HISTORIC AND DESIGN REVIEW COMMISSION

August 03, 2016

HDRC CASE NO: 2016-290
ADDRESS: 127 CROFTON
LEGAL DESCRIPTION: NCB 941 BLK 4 LOT E 172.85 FT OF 12 & E 182.1 FT OF S 1/2 OF 11
ZONING: RM4 H HS RIO-4
CITY COUNCIL DIST.: 1
DISTRICT: King William Historic District
LANDMARK: McNulty / Travelers House
APPLICANT: Nate Manfred/French & Michigan
OWNER: Greg & Delores Ellis
TYPE OF WORK: Front sidewalk installation
REQUEST:

1 Ground Floor Site Plan
Scale: 1/8"=1'-0"

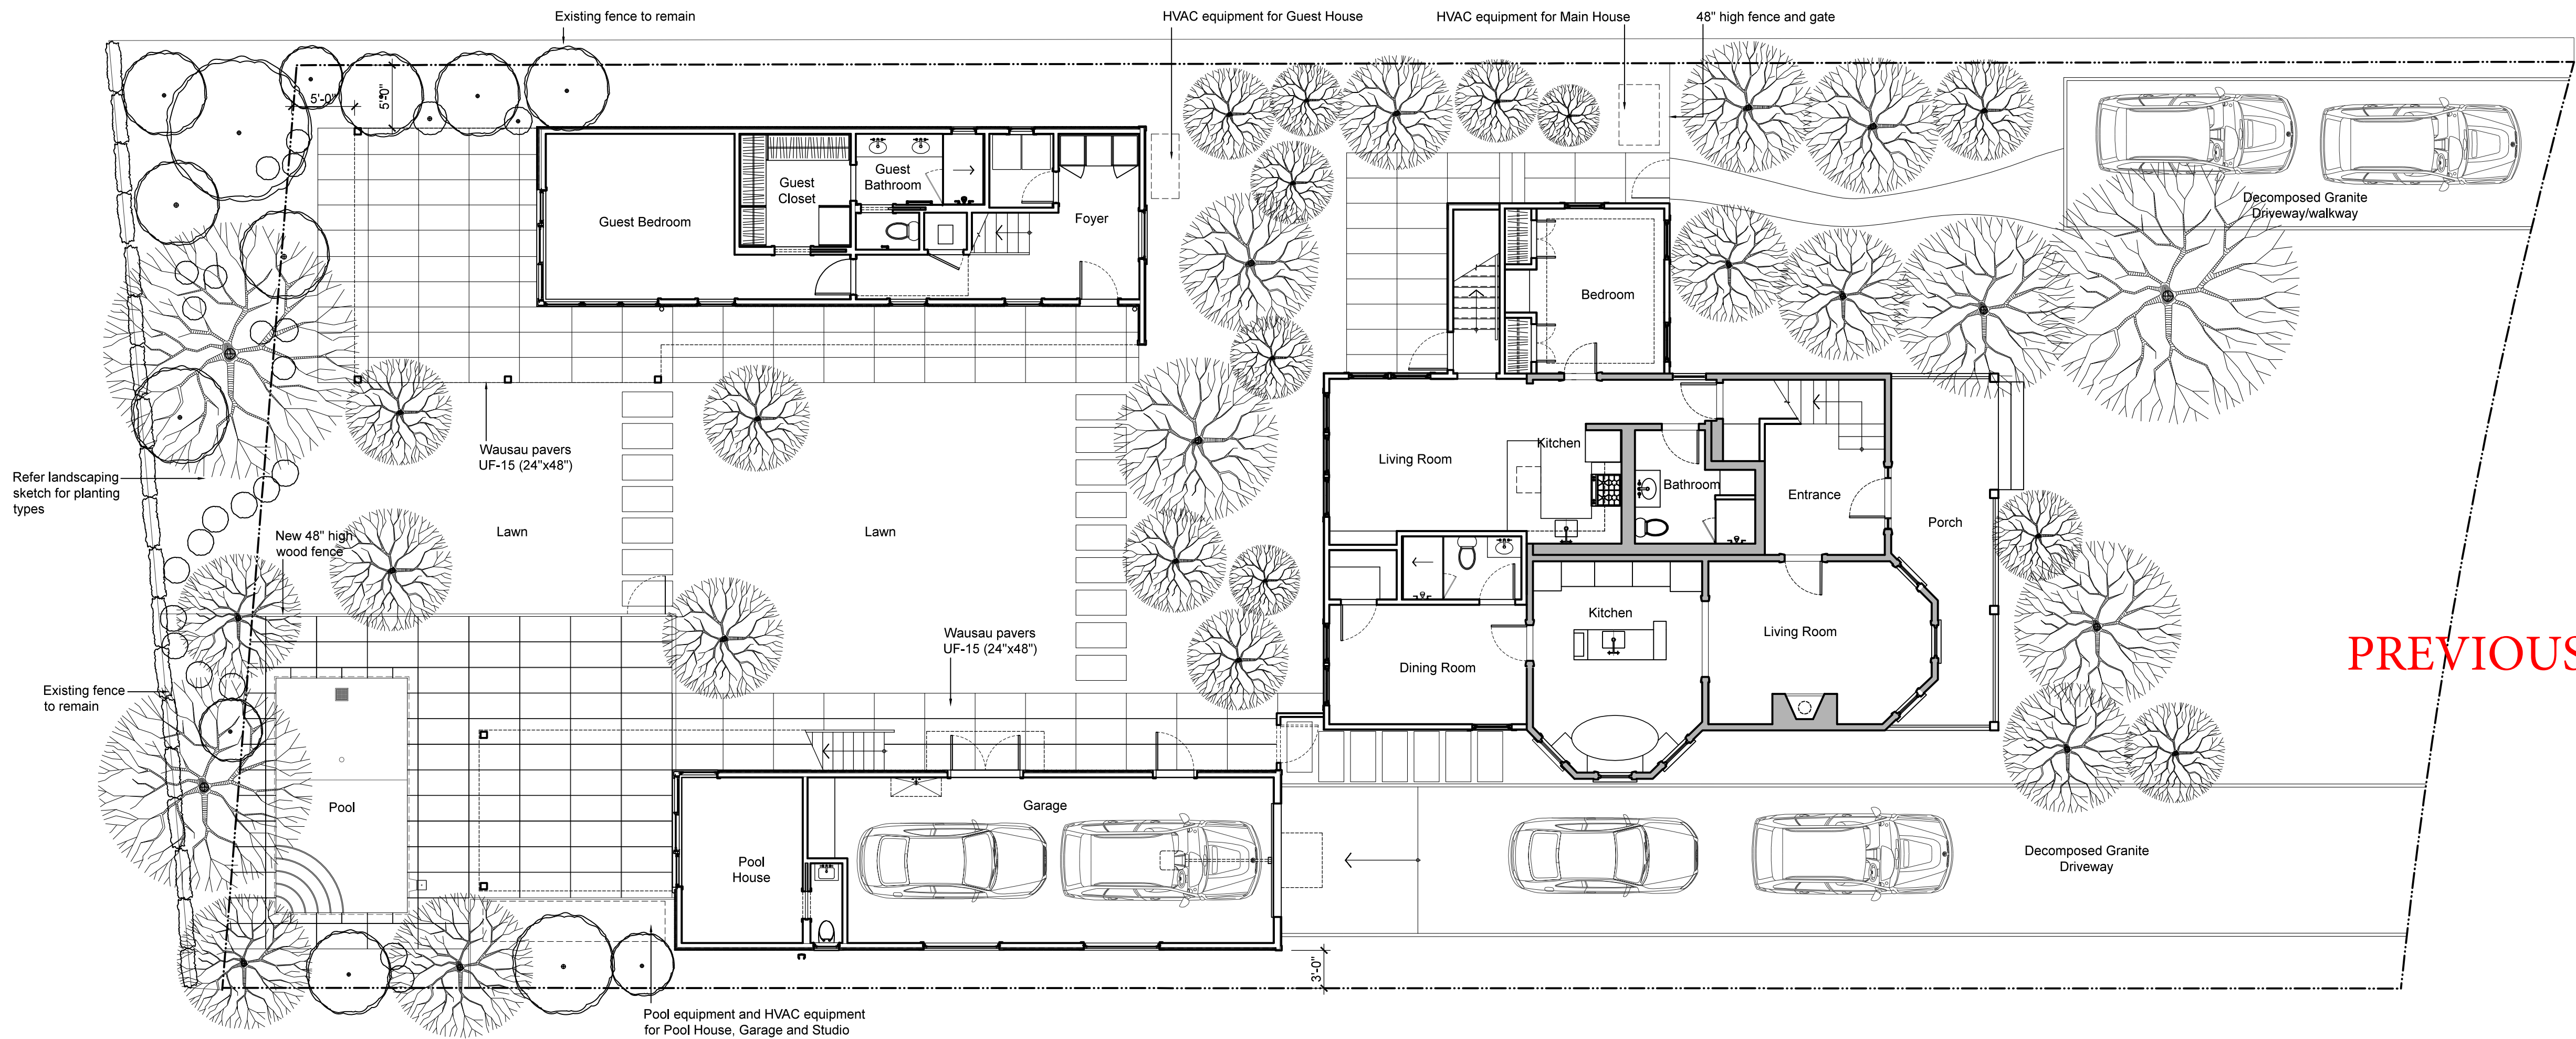
- b. The original front sidewalk was removed to facilitate front yard landscaping through the course of the rehabilitation of the primary historic structure. The original front sidewalk was approximately three (3) feet in width and straight. The applicant has proposed a new walkway that features a width of five (5) feet at the public right of way and a width of seven (7) feet at the front porch of the primary historic structure. Materials include midnight path gravel and concrete pavers that are 24" x 48". Typically, front yard sidewalks in the King William Historic District are straight; however, there are examples of varying widths, designs and materials that are found, particularly on Crofton. Staff finds the applicant's proposal appropriate and reversible.

- c. The applicant has proposed to install a side yard walkway on the north side of the lot northern parking location to the side addition of the primary historic structure. Staff finds the applicant's proposed materials, location and design appropriate and consistent with the Guidelines for Site Elements 3.B.

Staff recommends approval based on findings a through d.

PREVIOUSLY APPROVED SITE PLAN

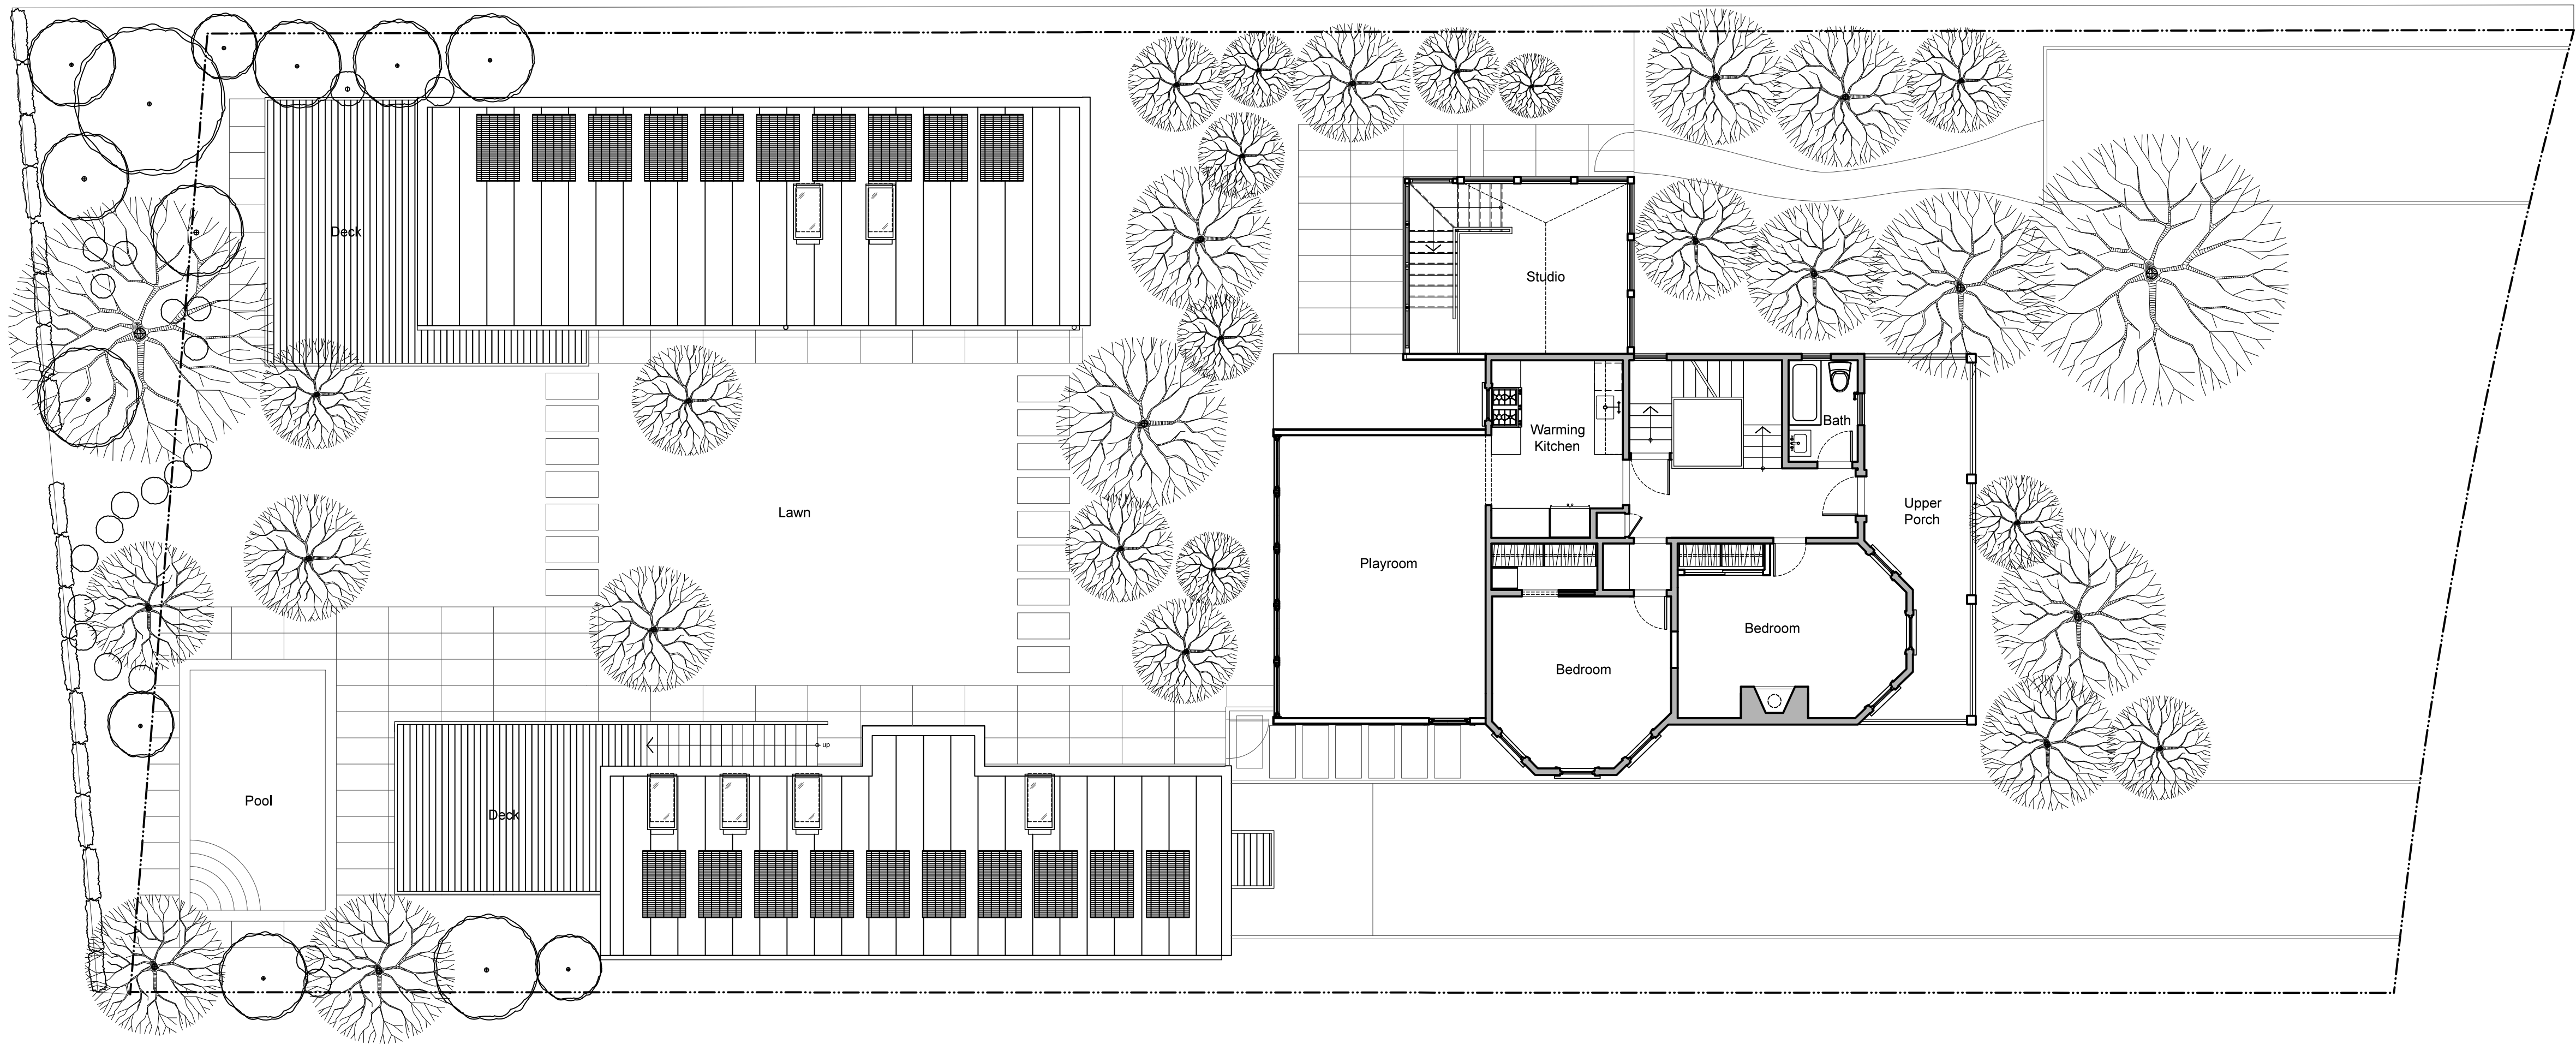
- d. The applicant has proposed to modify the previously approved parking surfaces' materials from decomposed granite to midnight path gravel. Staff finds that both materials are similar in nature and that the applicant's proposed material is appropriate.
